MONTGOMERY COUNTY PLANNING DEPARTMENT

MEMORANDUM

Re: Supplemental Memo for Pooks Hill
Sketch Plan Amendment No. 32015006A and
Site Plan Amendment No. 81982098C

Figure 1: Revised Site Plan Amendment for Entire 19.38-acre property
(Proposed Bocce Court highlighted in orange)

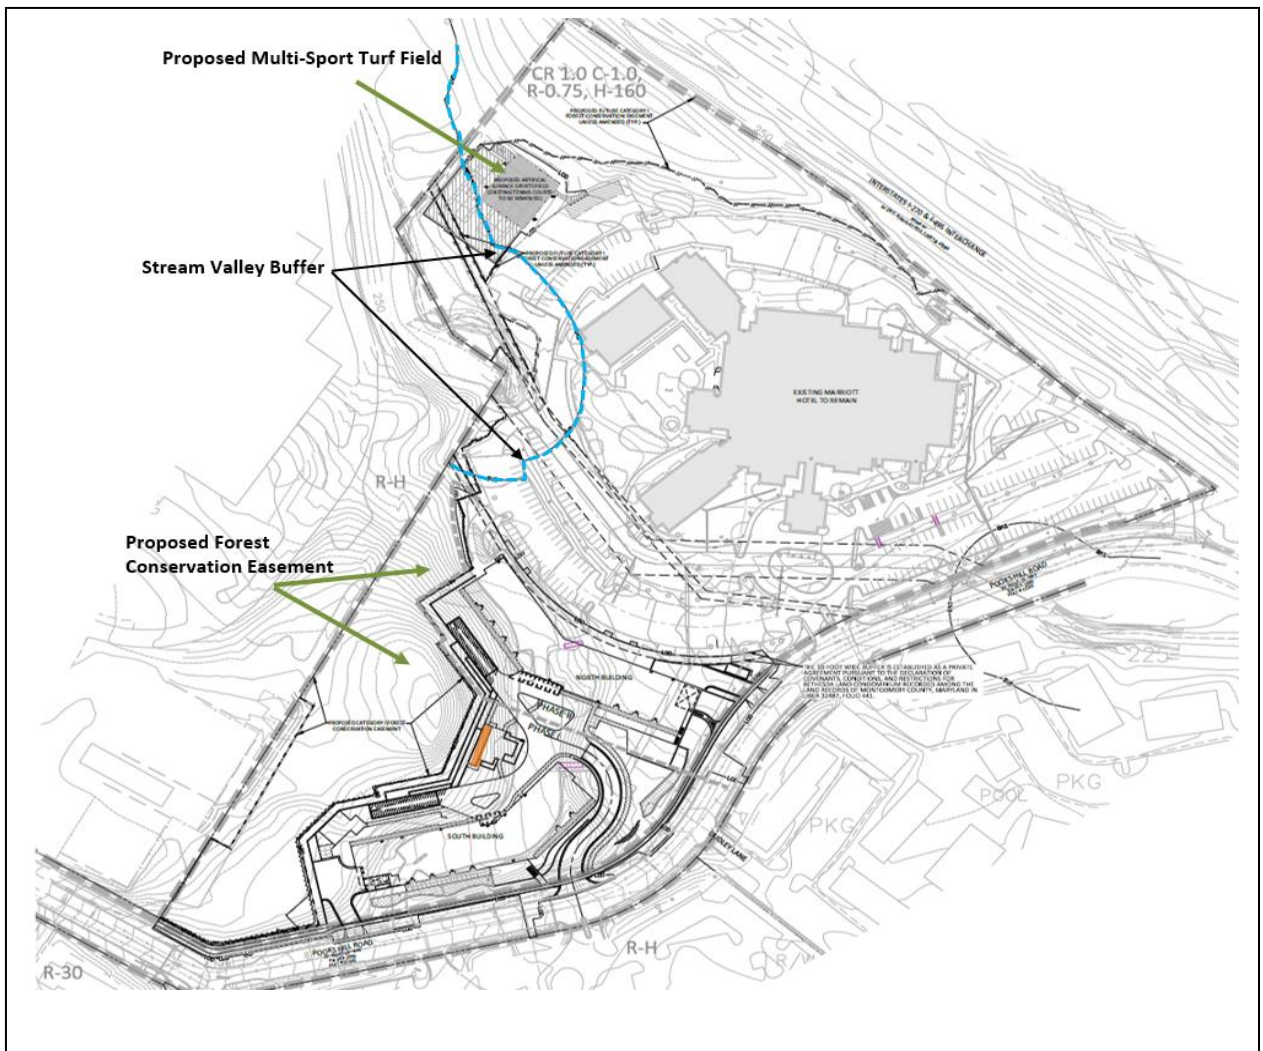
Figure 1 shows the Applicant's overall changes to the entire property proposed by the revised Site Plan Amendment. Figure 2 is the Applicant's rendering of the Multi-Family Unit with the removal of the natural surface trail and addition of the bocce court.

Figure 3: Hotel Unit Location of Former Tennis Courts and Proposed Multi-Sport Turf Field, Stream Valley Buffer shown in Blue

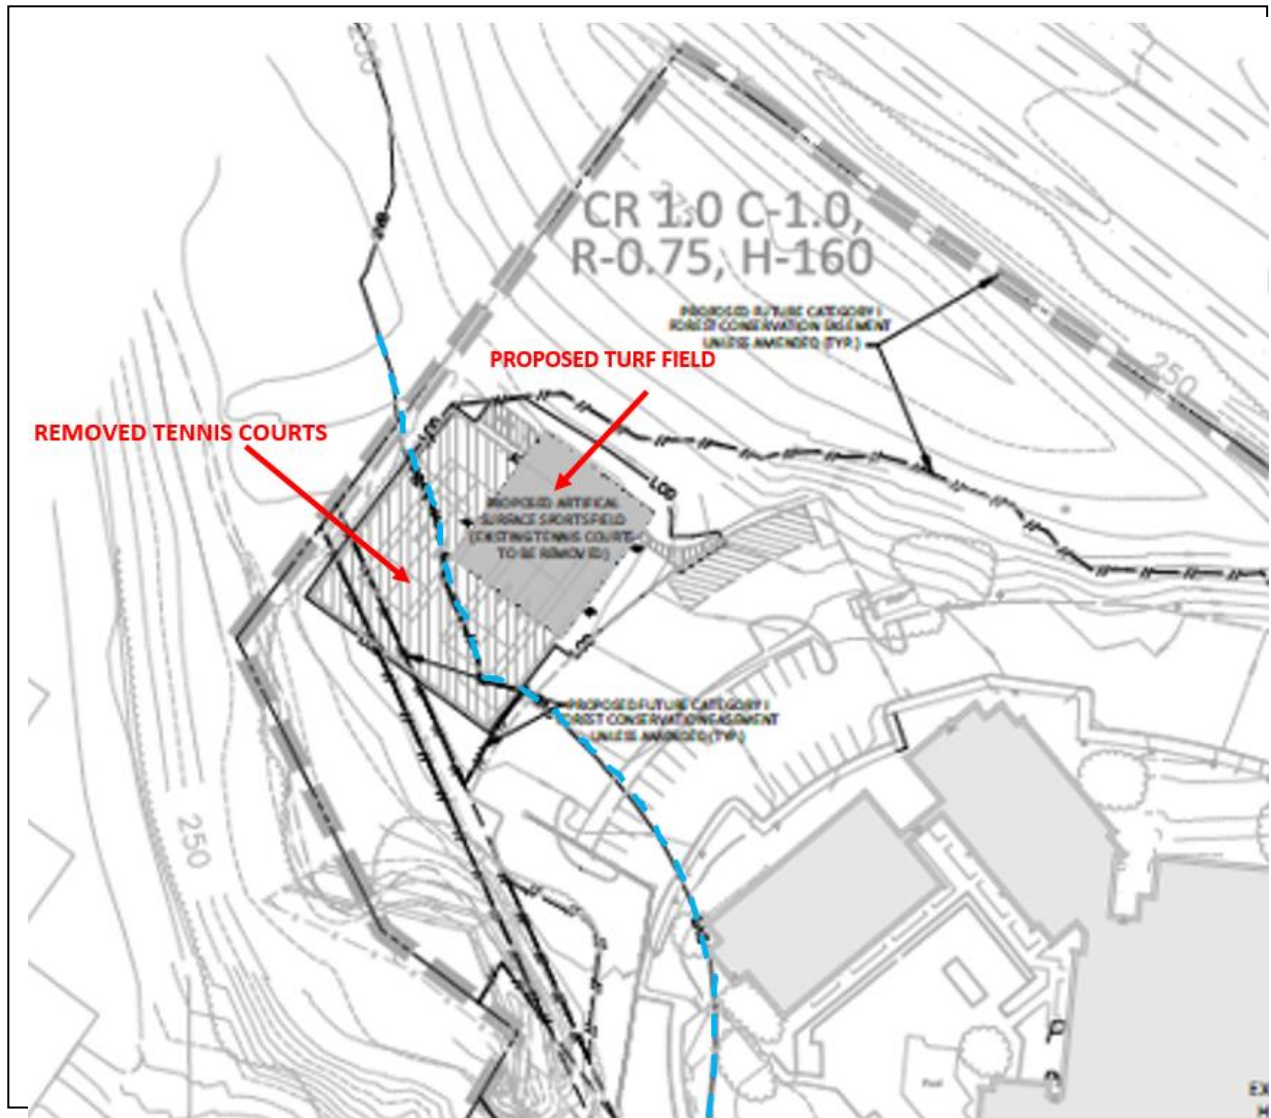
The revised Site Plan Amendment shows the removal of two dilapidated tennis courts from the SVB on the Hotel unit. The two tennis courts have been replaced with a multi-sport turf field located outside of the SVB. The tennis courts comprised approximately 13,794 square feet with approximately 5,450 feet within the SVB, while the proposed multi-sport turf field will be 5,600 square feet and completely outside of this critical SVB.

The turf field will be lighted however, the submitted lighting plan did not accurately reflect future lighting conditions at the western property line which abuts residentially zoned property. At the time of certified site plan review, the Applicant will need to submit a more complete lighting plan for staff review and approval.

Figure 4: Proposed Natural Surface Trail on Multi-Family Unit (trail shown in brown)

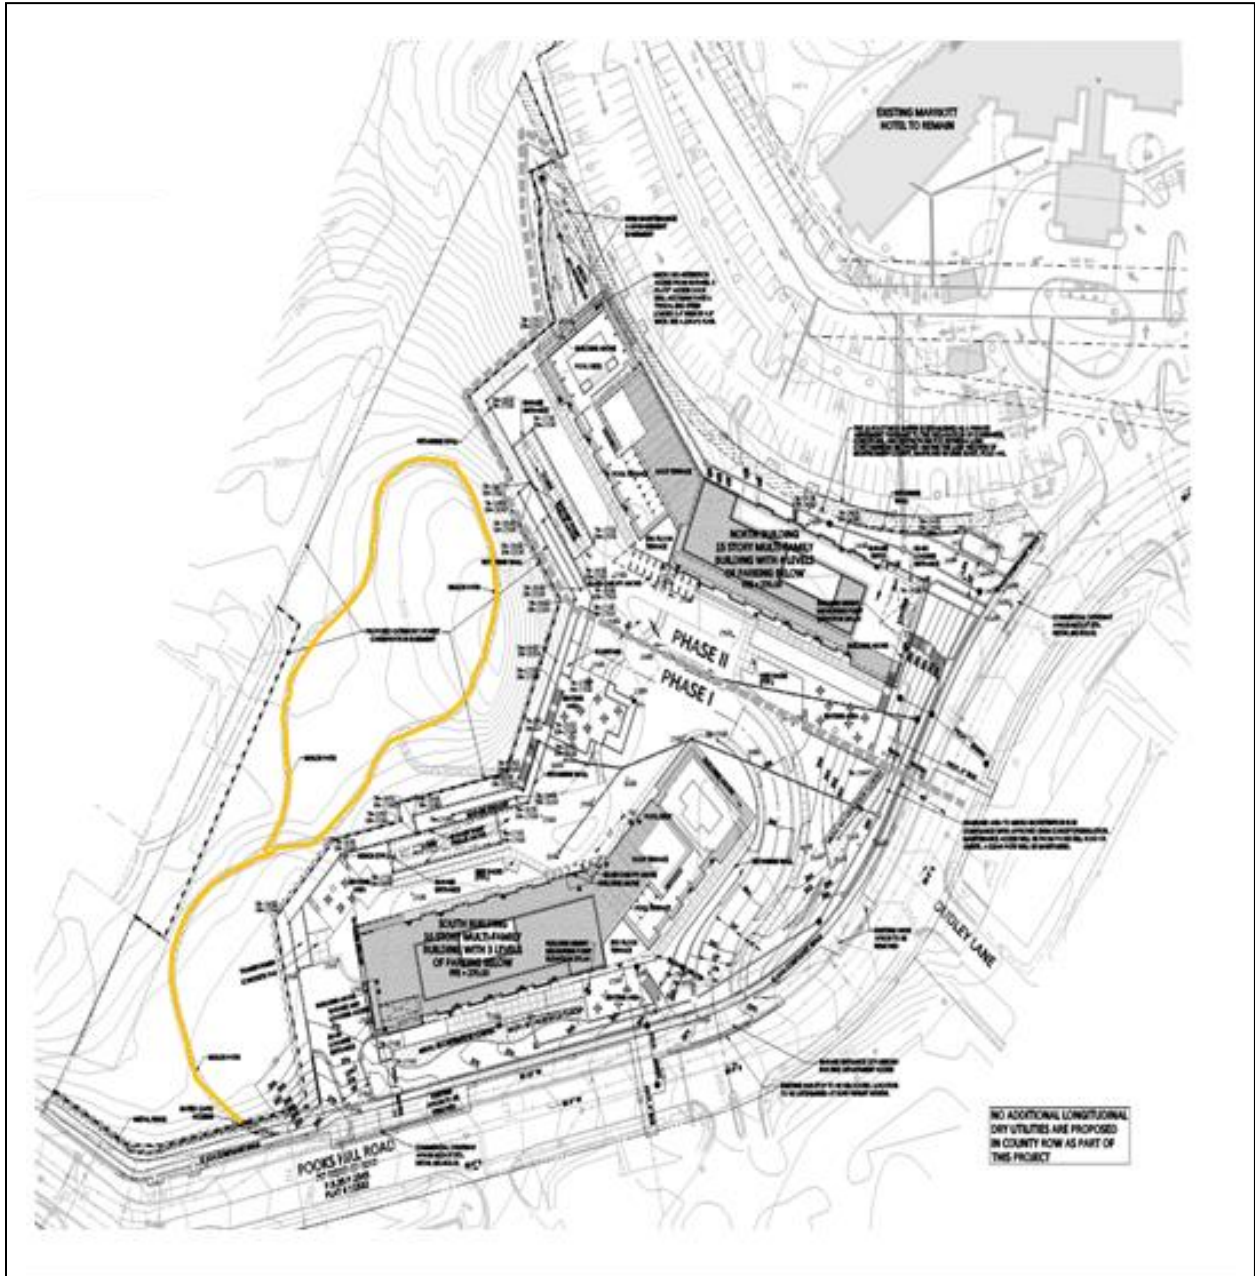
During the September 22, 2016, public hearing, the Planning Board requested that the Applicant explore ways to make the natural surface walking trail ADA compliant. For reference, Figure 4 below shows the location of the originally proposed natural surface walking trail.

Based on the grading studies, the Applicant proposes not to build the trail and to leave the proposed forest conservation easement area undisturbed on the Multi-family unit. To compensate for the loss of the natural surface trail, the Applicant proposes to add another recreational amenity, one bocce court. This bocce court will be located in the central plaza area between the two multi-family residential buildings. It will be accessible to all residents and visitors to the site. Moreover, its location in the central courtyard coupled with proposed seating in this area will create another on-site gathering spot for relaxing.

To avoid significant forest disturbance, Staff the supports removal of the natural surface walking trail and replacement of it with one bocce court in the central plaza.

Figure 6: Applicant's Alternative 1: Views from Sections A-A'

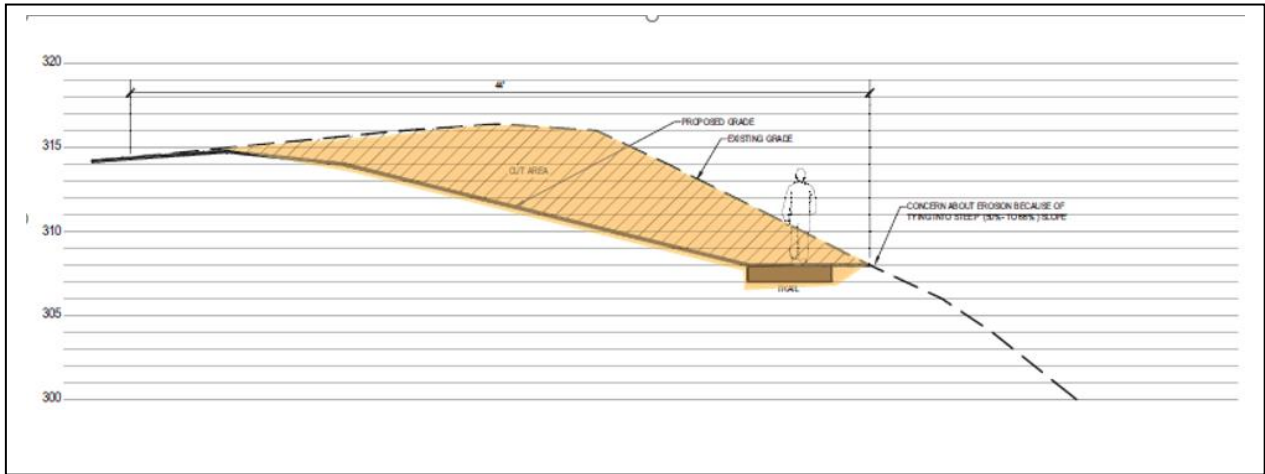
The Applicant's grading studies for both Alternatives indicate that keeping the trail at 5% or less as required by ADA standards would require significant "cut", negatively impacting the screening values, and environmental benefits provided by the existing vegetation. Additionally, the Applicant states that the amount of clearing and the potential for erosion would create additional environmental impacts to site. Attachment A contains the Applicant's Justification letter.

Figure11: Applicant’s Exhibit Proposed Plantings for Stormdrain Easement

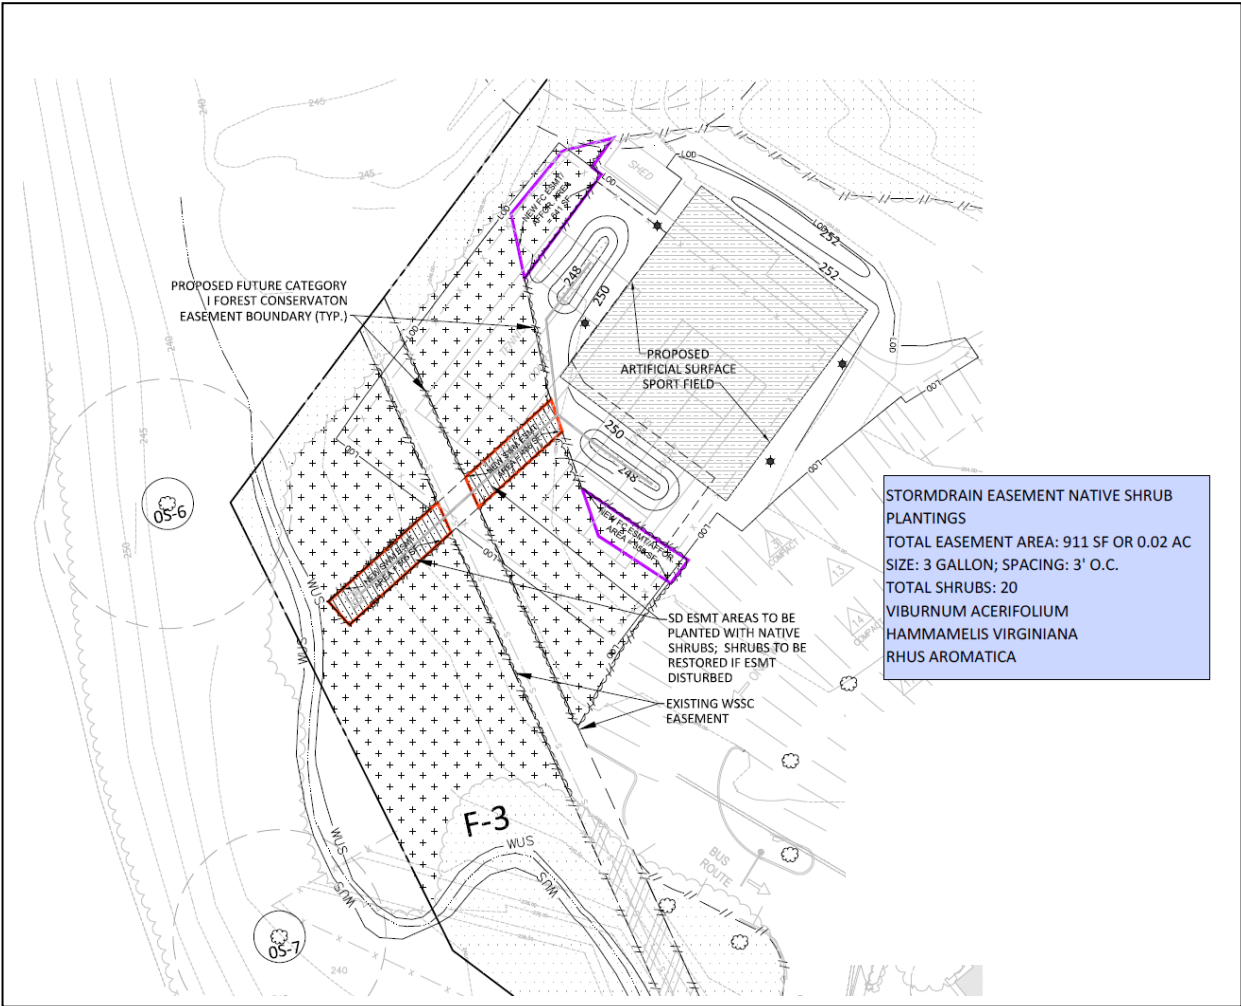
On February 5, 2016, Department of Permitting Services (DPS) approved stormwater management concept plan (#280376) for the development. With the subsequent removal of the tennis courts the Applicant was required to submit a stormwater management concept plan to address impacts from the proposed turf field and a proposed storm drain easement through the proposed forest conservation easement area. Discussions with staff, the Applicant, and DPS produced an exhibit to increase the amounts of plantings within the storm drain easement. Staff supports the Applicant's Exhibit shown in Figure 11 for these additional plantings and the FCP will need to be revised to incorporate this planting area. A condition of approval for these revisions is recommended. The stormwater management concept plan (#282545) was approved by DPS on April 18, 2017. This Plan proposes to meet stormwater management requirements through landscape infiltration and micro-bioretenion facilities. DPS approval letters for both stormwater management concept plans are contained in Attachment B.

- a. Ensure consistency of all details and layout between Site and Landscape Plans.
- b. Coordinate with Staff on any necessary minor plan revisions, clarifications, and corrections within the Final Forest Conservation Plan.
- c. Submit a lighting plan for each rooftop deck and for the multi-sport turf field.
- d. Include the stormwater management concept approval letters, development program, Sketch Plan Amendment and Site Plan Amendment resolutions on the approval or cover sheet(s).
- e. Modify the Site Plan Amendment Data Table to include acreage for the Hotel Unit.
- f. Revise Forest Conservation Plan to reflect location of the stormdrain easement outfall pipe on the Hotel Unit to include planting types, amounts and notes per the Applicant's Exhibit submitted April 24, 2017.
